Re: Petition No. 1533A - ReNew Developers, LLC Declaratory Ruling, pursuant to Connecticut General Statutes §4-176 and §16-50k, for the proposed construction, maintenance and operation of a customer-side 4.99-megawatt fuel cell facility and associated equipment to be located at 42 Old Amston Road, Colchester, Connecticut.

Enclosed for filing with the Connecticut Siting Council ("Council") are ReNew Developers, LLC's responses to the Council's first set of interrogatories dated August 17, 2023.

# Attachment CSC-5-1

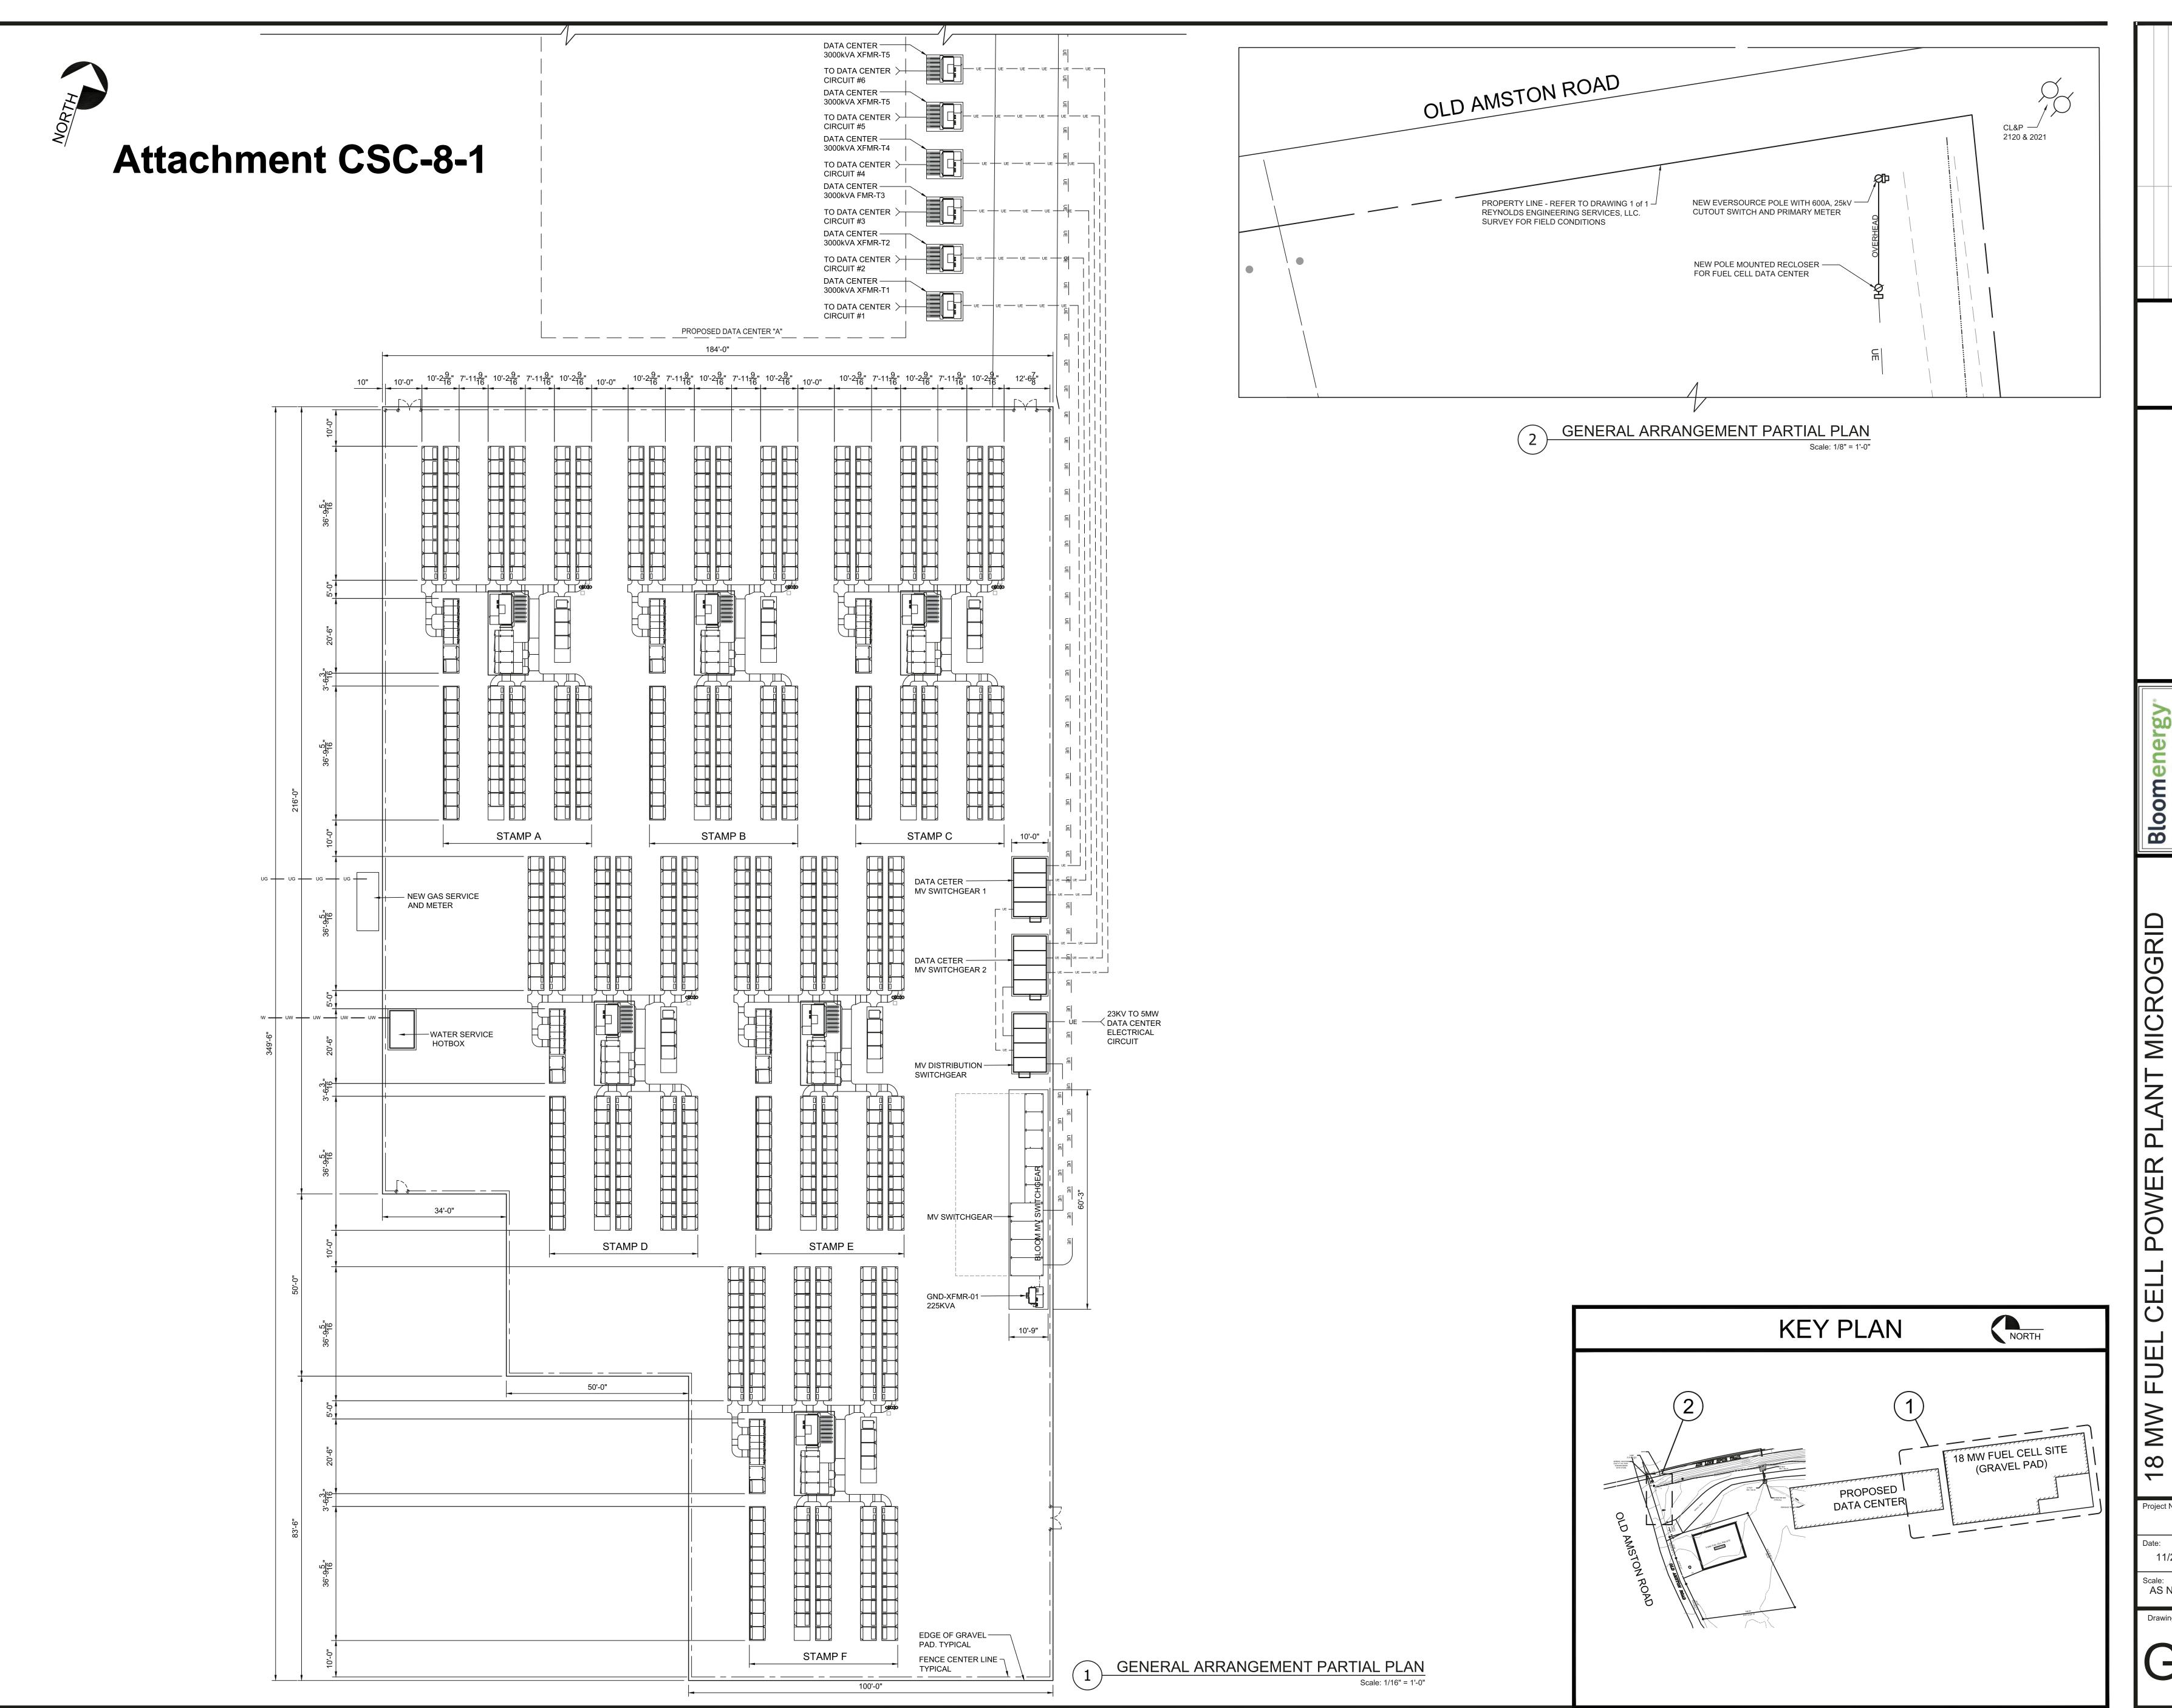
Q-CSC-5: Provide site plans showing the location of the data center in relation to the

approved fuel cell facility and the proposed fuel cell facility.

A-CSC-5: Please see Attachment CSC-5-1 depicting the location of the planned data

center.
